SERVICE BULLETIN

N° **189-300**

ATA 28 - FILLER CAP CORROSION PROTECTION

This Service Bulletin provides the necessary instruction on how to improve the corrosion protection of the filler cap.

Figure 5

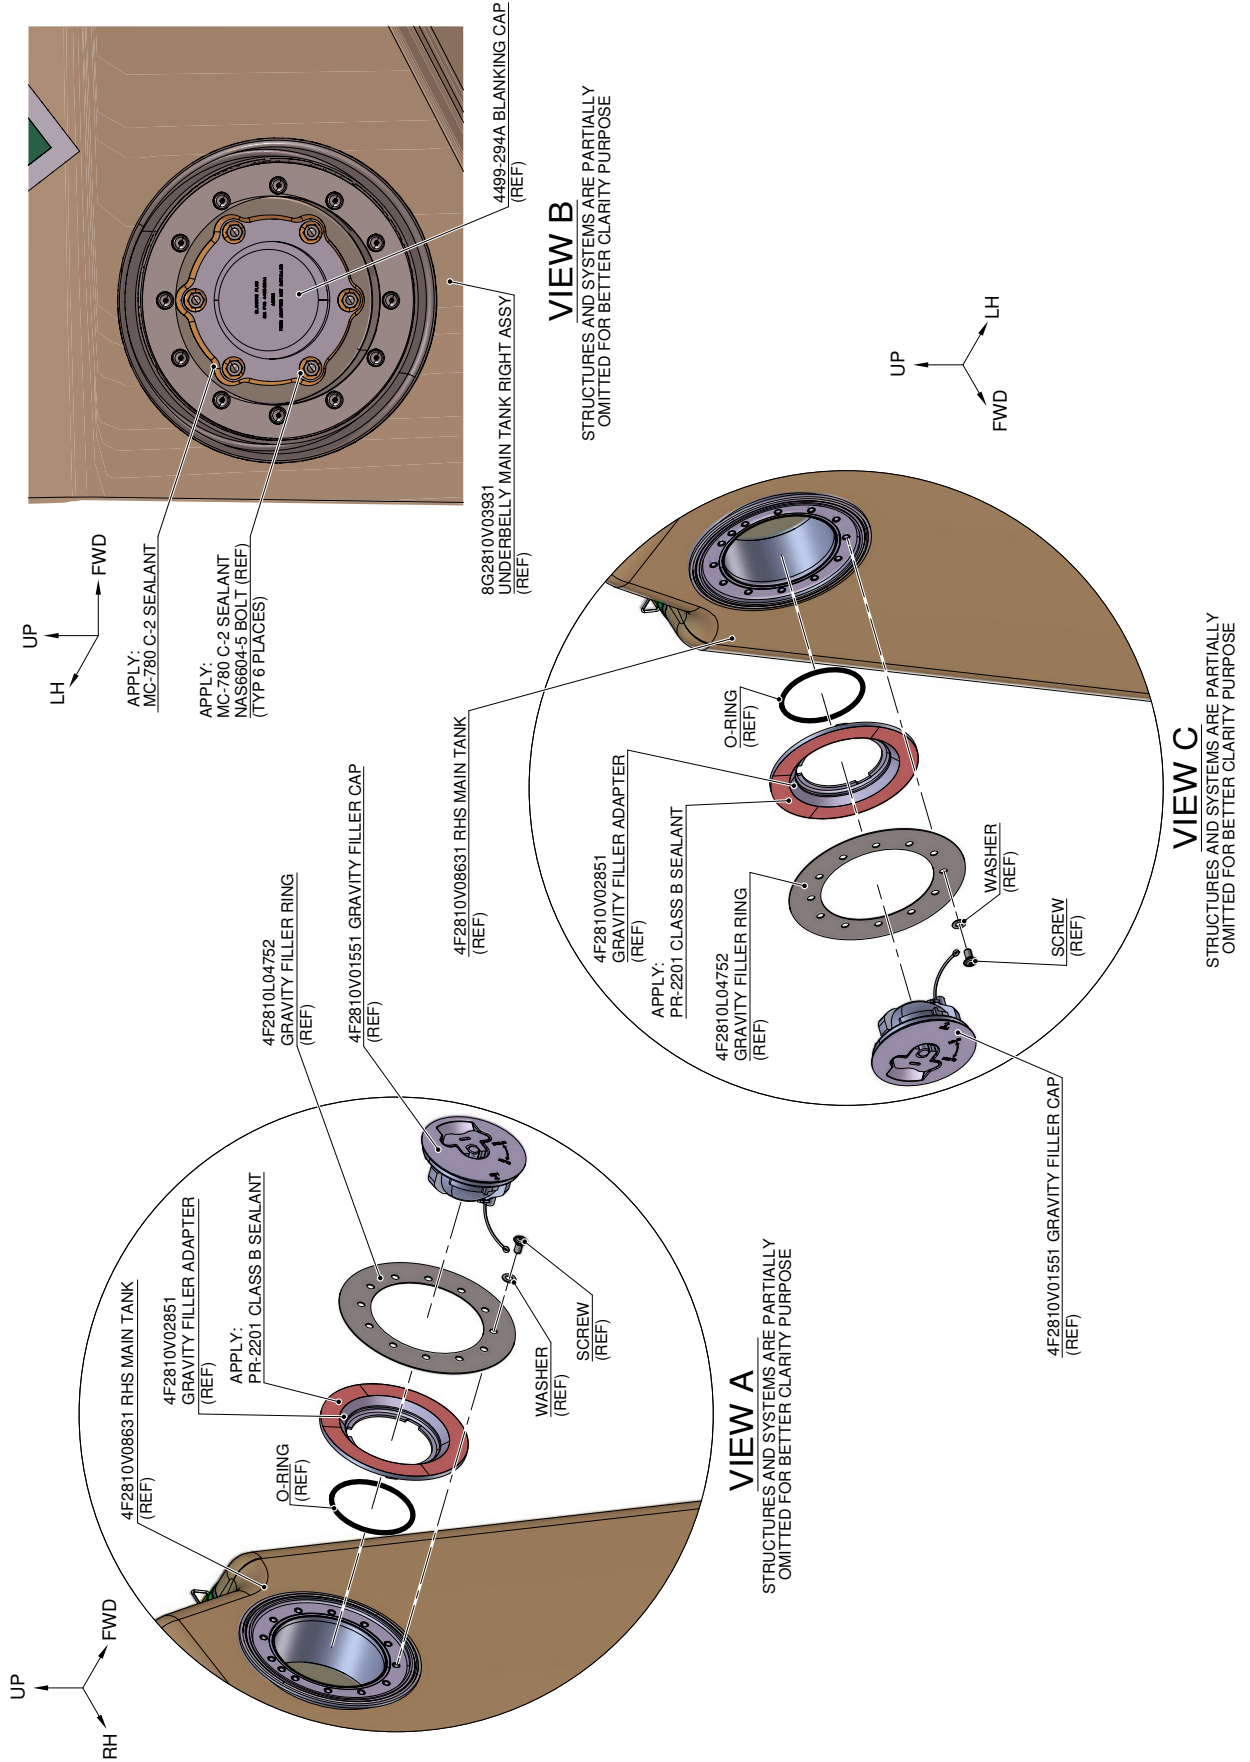
5. In accordance with AMP DM 89-A-28-11-19-00A-720A-A and with reference to Figure 5 View A, re-install the filler ring P/N 4F2810L04752 and the filler adapter P/N 4F2810V02851 by means of the previously removed hardware (Ref. to Step 4).
6. In accordance with AMP DM 89-A-28-11-16-00B-720A-A and with reference to Figure 5 View A, re-install the filler cap P/N 4F2810V01551 previously removed hardware (Ref. to Step 3).
7. In accordance with AMP DM 89-A-28-11-16-00B-520A-A and with reference to Figure 5 View C, remove the filler cap P/N 4F2810V01551.
8. In accordance with AMP DM 89-A-28-11-19-00A-520A-A and with reference to Figure 5 View C, remove the filler ring P/N 4F2810L04752 and the filler adapter P/N 4F2810V02851 with the related hardware.

9. In accordance with AMP DM 89-A-28-11-19-00A-720A-A and with reference to Figure 5 View C, re-install the filler ring P/N 4F2810L04752 and the filler adapter P/N 4F2810V02851 by means of the previously removed hardware (Ref. to Step 8).

10. In accordance with AMP DM 89-A-28-11-16-00B-720A-A and with reference to Figure 5 View C, re-install the filler cap P/N 4F2810V01551 previously removed hardware (Ref. to Step 7).
11. With reference to Figure 4 and Figure 5 View B, if “kit pressure refuel” is not installed, perform the corrosion protection with a full perimetrical sealing to the blanking cap edge P/N 4499-294A and to the heads of n°6 bolts P/N NAS6604-5 by means of sealant MC-780 C-2 (C465).
